Preliminary Design Report

Adopt A Stream Foundation

February 2014

Salmon Recovery Funding Board Individual Comment Form

SRFB PROPOSAL
(AASF 2012 BEAR CREEK REACH 6 RESTORATION
12-1282)

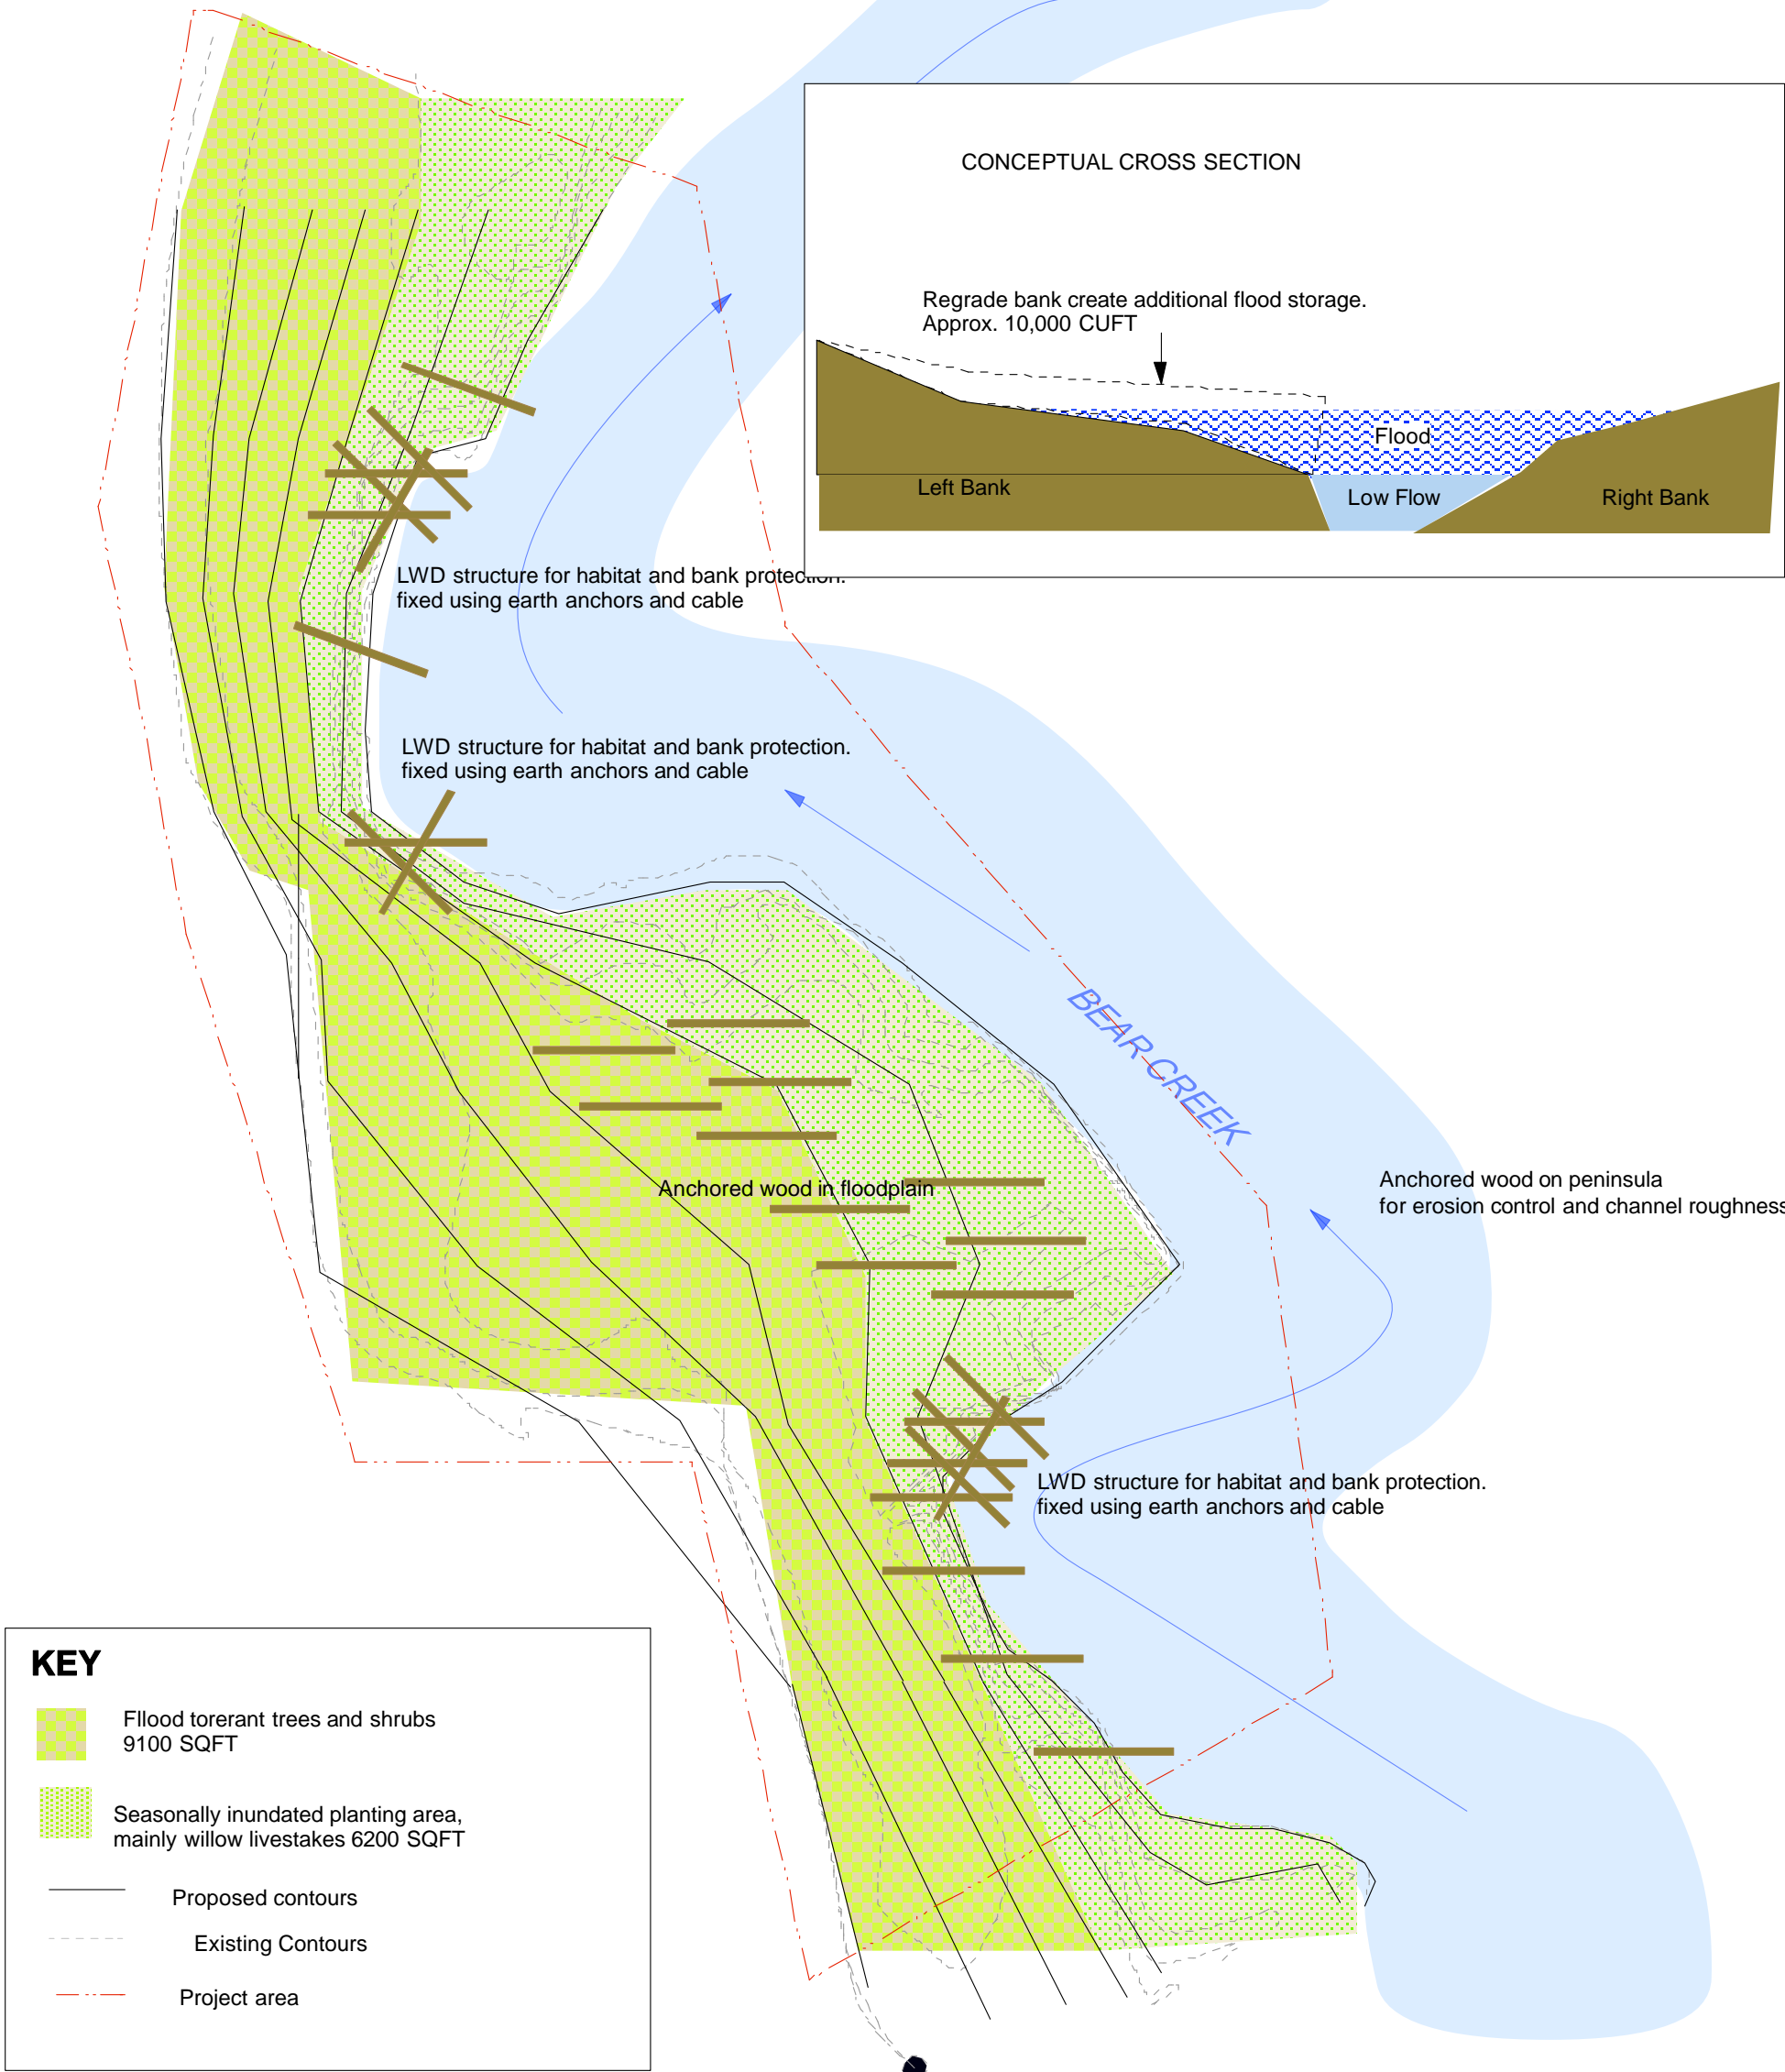
We also caution the sponsor to avoid giving the property owner the impression that regrading the left bank will make a significant reduction in flooding at the site, unless appropriate hydrologic and hydraulic modeling has been completed to

demonstrate that it will. The review panel's informal field observations suggest that channel constriction by structures immediately downstream of the site will backwater the site during flood conditions, regardless of the proposed bank regrading.

Because of the significant uncertainties associated with the effectiveness and sustainability of the bank regrading component of the design, the review panel suggests that the sponsor focus instead on installing abundant LWD pieces along the existing left bank to enhance salmon habitat complexity and reduce bank erosion. Please also consider the merits of installing a mid channel LWD structure that is positioned to deflect high flows over the point bar on the inside of the meander, and which will further improve habitat complexity. We strongly support the proposed revegetation component of the project, especially if it can retain the existing large cottonwood tree on the left bank.

AASF concurs with that assessment. The property owner is aware that this project will not make a significant reduction in flooding. Our position is that the project will marginally increase flood storage at the site and it should be managed as a frequently flooded area, that is, planted with native vegetation and allow for controlled channel change. We have also advocated that all frequently flooded areas on the property should be managed as such. He is also aware that downstream constrictions affect flooding and will continue to backwater his property especially the project area.

Conceptually the plans have been changed to de-emphasize excavation and instead spend additional resources on LWD. However, re-grading the bank especially on the outside bend will be necessary to eliminate sheer banks. A gradual slope will allow for properly installed LWD structures and provide expanded planting areas. During the site visit the committee suggested a side channel on the left bank in the project area. AASF will explore a full (year round) side channel during final design; currently it is not the preferred option due to limited space on the left bank and increased implementation and engineering cost. A high flow channel near the left bank (winter channel) will likely be part of the final design but it will be subject to cost and design constraints.

Based on our experience installing LWD this summer at this site the design will need to account for very sandy alluvial soils. Rebar anchoring will not be effective - earth anchors will need to be sized appropriately for conditions which means larger earth anchors. Longer logs are needed at this site in order to provide year round habitat benefits. Length is important so that the logs can be interacting with the water in the summer low flows and be securely anchored on the bank even in higher winter flows. A minimum of 20' appears to be necessary due to dramatically different summer and winter flows. Long logs and bigger earth anchors will have some affect on the quantity of wood used to remain within budget.

Native vegetation will be retained in the project area as appropriate. The large cottonwood tree and surrounding shrubs will be preserved.
